APPLICATION NO.	FILING DATE	FIRST NAMED INVENTOR	ATTORNEY DOCKET NO.	CONFIRMATION NO.
10/589,176	05/24/2007	Haiko Adolf	2003P17895WOUS	5892
22116 SIEMENS COF	7590 02/25/201 RPORATION	EXAMINER		
INTELLECTUAL PROPERTY DEPARTMENT 170 WOOD AVENUE SOUTH ISELIN, NJ 08830			GONZALEZ QUINONE, JOSE A	
			ART UNIT	PAPER NUMBER
,			2834	
			MAIL DATE	DELIVERY MODE
			02/25/2010	PAPER

A 11 (1 A)	A 11 (1)			
	Application No.	Applicant(s)			
Office Action Summary	10/589,176	ADOLF ET AL.			
,	Examiner	Art Unit			
	JOSE A. GONZALEZ QUINONES	2834			
The MAILING DATE of this communication appears on the cover sheet with the correspondence address Period for Reply					
A SHORTENED STATUTORY PERIOD FOR REPLY IS SET TO EXPIRE 3 MONTH(S) OR THIRTY (30) DAYS, WHICHEVER IS LONGER, FROM THE MAILING DATE OF THIS COMMUNICATION. - Extensions of time may be available under the provisions of 37 CFR 1.136(a). In no event, however, may a reply be timely filed after SIX (6) MONTHS from the mailing date of this communication. - If NO period for reply is specified above, the maximum statutory period will apply and will expire SIX (6) MONTHS from the mailing date of this communication. - Failure to reply within the

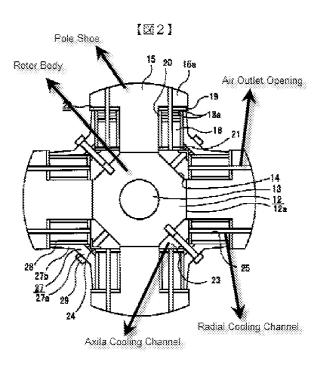
However Kibe et al. discloses pole shoe (15) including an air outlet opening (see annotation figure 2) and the field coil (18) includes a radial cooling channel (25) extending from the axial cooling channel (23) to the air outlet opening (see annotation figure 2), with radial cooling channel (25) extending radially outward with respect to the axial direction of the rotor body (12), and wherein the radial cooling channel (25) is in connection with the axial cooling channel (23) to allow flow of the cooling medium from the axial cooling channel (23) and through the radial cooling channel (25) and through the air outlet opening (see annotation figure 2) of the pole shoe (15) as shown in figure 2.
